Special Exception Royal Farms #411 (Kent Village)

SE-4834

| REQUEST | STAFF RECOMMENDATION |

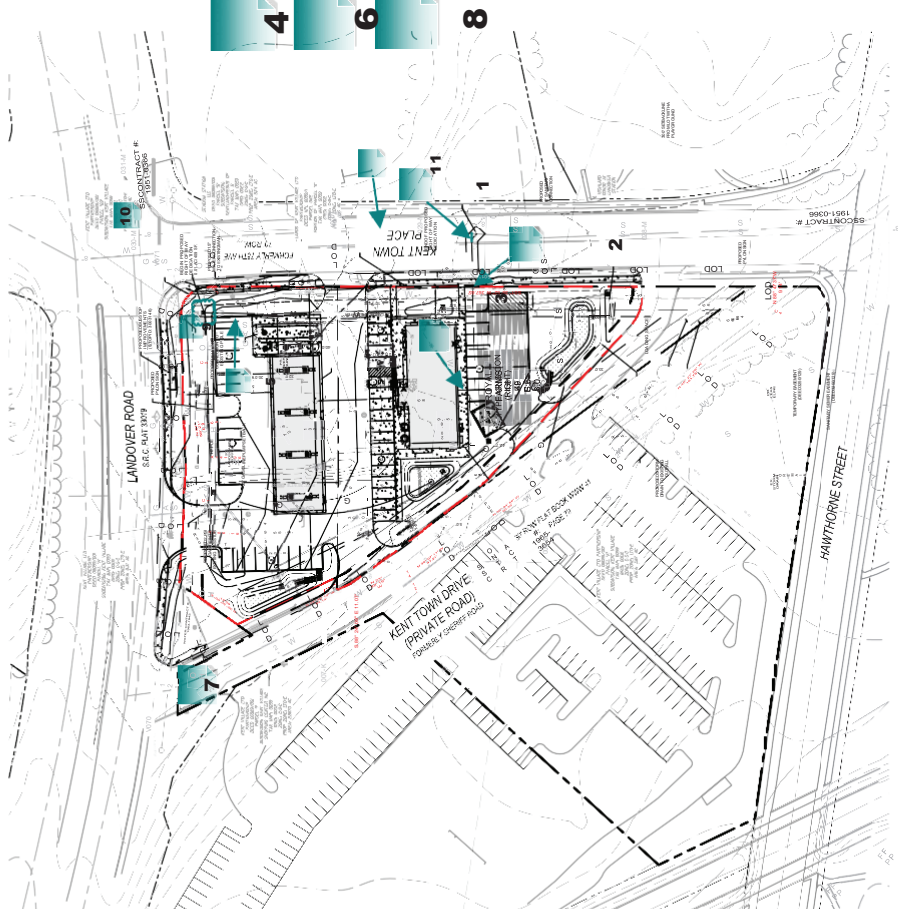
12. **Signage:** The signage chart, sign details, and sign location key map shown on Sheet 5 of the special exception plan requires revisions, due to numerous inconsistencies and errors. For example, the signage chart shows five canopy-mounted signs provided, but the plans only show three. Plans show locations for signage types six and nine, for which no details are provided, and they are not accounted for in the signage chart. The chart notes two directional signs are provided, but the plans show four. A new signage plan is needed with all required information for the proposed signage for this development.

Freestanding signage–The site plan shows six freestanding signs with advertising. There are two larger signs with gas station pricing and four smaller directional signs. The proposed signs on the signage plan should be revised, in accordance with Section 27-614(d)(2) of the Zoning Ordinance. The directional signs with advertising must be removed from the plan entirely, or can be retained, provided all advertising for the Royal Farms business is removed. Furthermore, site plans display the labeling of two pylon signs proposed, but details show monument signs instead.

Building and canopy-mounted signage–The series of building and canopy-mounted signage shown on the plans appear to be in general conformance with the applicable requirements of Section 27-613 of the Zoning Ordinance. However, as previously noted, the signage plan in general requires several corrections and clarifications to demonstrate conformance with Part 12, Signs.

1. Prior to certificate approval, the applicant shall revise the special exception plan and provide additional information as follows:
 - a. Provide a new signage plan, including clearly identifying the number and location of freestanding signs, to demonstrate conformance with the applicable requirements of Part 12, Signs, of the Prince George's County Zoning Ordinance.
